DEVELOPMENT REVIEW BOARD MEETING

2. **Res. No. 438 Frog Pond Ridgecrest Subdivision.** The applicant is requesting approval of Annexation to the City of Wilsonville and Rezoning of approximately 9.00 acres, a Stage 1 Preliminary Plan, Stage 2 Final Plan, Site Design Review of parks and open space, Tentative Subdivision Plat, Type C Tree Removal Plan, Middle Housing Land Division, and Waivers for a 28-lot residential subdivision.

DB24-0008 Frog Pond Ridgecrest Subdivision

Exhibit A1
Staff Report
Wilsonville Planning Division
Frog Pond Ridgecrest 28-Lot Subdivision
Development Review Board Panel 'A'
Quasi-Judicial Public Hearing

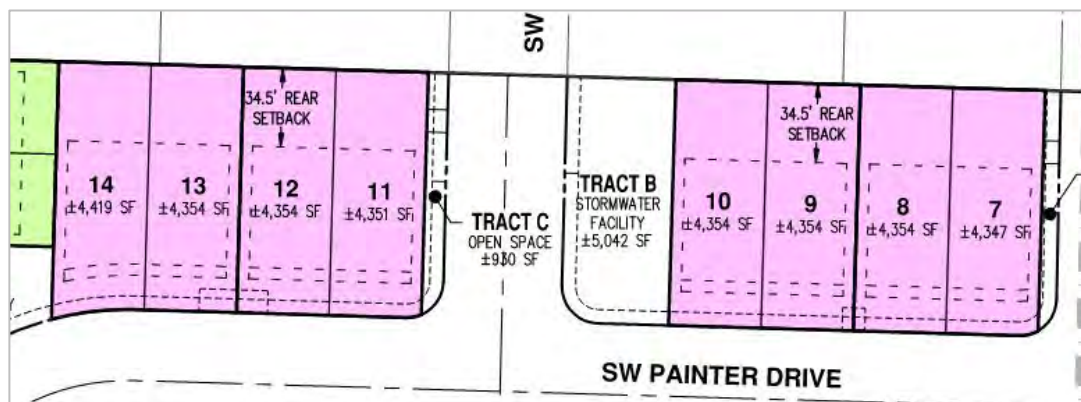
I1. Per Subsection 4.118 (.03) A. 1., the Development Review Board, based on findings of fact supported by the record, may waive the minimum lot area standard. While all parent lots proposed within R-7 Sub-district 4 exceed the minimum lot area standard of 6,000 square feet, Lots 4-8 and 16-23 exceed the maximum allowed size for middle housing land division units, which is restricted by Section 4.232 (.03) F. 2., to be, on average, equal to 60% or less of the minimum lot size of the zone on lots in subdivision or partitions recorded in the prior 24-month period.

In R-7 Sub-district 4, the maximum size based on the standard is 3,600 square feet per middle housing land division unit. In the proposed subdivision, parent Lots 4-8 and 16-23 range in size from 7,602 to 8,773 square feet, resulting in middle housing land division units on these lots ranging in size from 3,795 to 4,419 square feet, with an average of 4,036 square

feet, which is 112% of the sub-district maximum lot size. Thus, a waiver is requested to the maximum lot size restriction for middle housing land division units for parent Lots 4-8 and 16-23 (middle housing land division Units 7-14 and 30-42 (Sheet P-09, Exhibit B2).

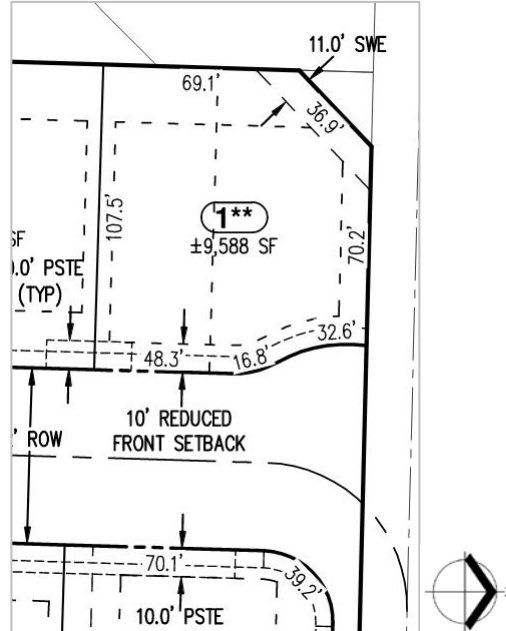
- I5. Subsection 4.118 (.03) A. 3. allows the Development Review Board to waive yard requirements based on findings of fact supported by the record. The applicant requests a waiver to reduce the front yard setback from 20 feet to 10 feet for Lot 1 in R-10 Sub-district 7 (a 50% reduction) and from 15 feet to 10 feet for Lot 19 in R-7 Sub-district 4 (a 33% reduction).

As shown in the illustration below, the difficulty to meet the setback standards of Section 4.127 related to Lot 1 arises from the placement of the existing SW Frog Pond Lane “knuckle” right-of-way and the location of the Boeckman Creek Trail at the northwest corner of the lot, which was established in the previously approved Frog Pond Terrace subdivision. Per the applicant’s narrative Code response, retaining the standard front setback on this lot will require either a very shallow custom home on the northern middle housing unit or elimination of the dwelling unit (one (1) unit in a two-unit cluster). While the home would have a narrower front setback, it would remain generally even with the adjacent home (on the south portion of Lot 1) due to the proximity of the SW Frog Pond Lane eyebrow curve.

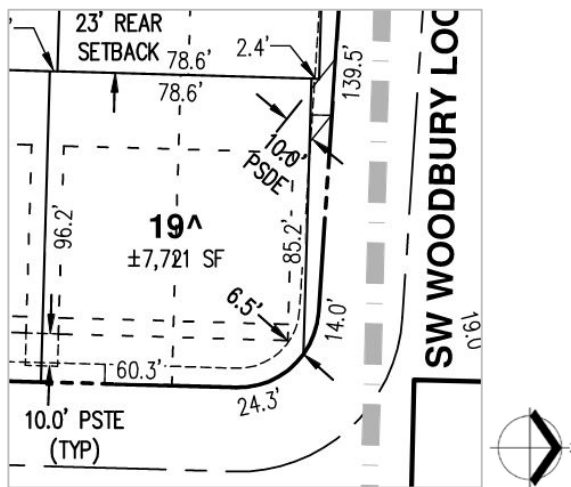
Related to Lot 19, as shown below, the northern middle housing land division unit on this lot experiences similar constraints to Lot 1. In order to accommodate right-of-way width to provide two-way traffic and looped utilities through the SW Woodbury Loop right-of-way adjacent to Tax Lot 1101, the front setback of Lot 19 must be adjusted. Per the applicant’s Code response narrative, the change will permit the northern home on Lot 19 (middle

housing Unit 36) to remain similarly sized, scaled, and positioned in relation to the southern home on Lot 19 (middle housing Unit 37). The front setback on Unit 37 would be forced to follow the curve of the SW Woodbury Loop right-of-way without the requested waiver. This would, in turn, force the home on this lot to be pulled back from the street, narrowing the home needlessly and creating a difficult home to build and live in. The garage location and setback will be unaffected by the requested waiver and is still planned to be located further south of the problematic northeast lot corner.
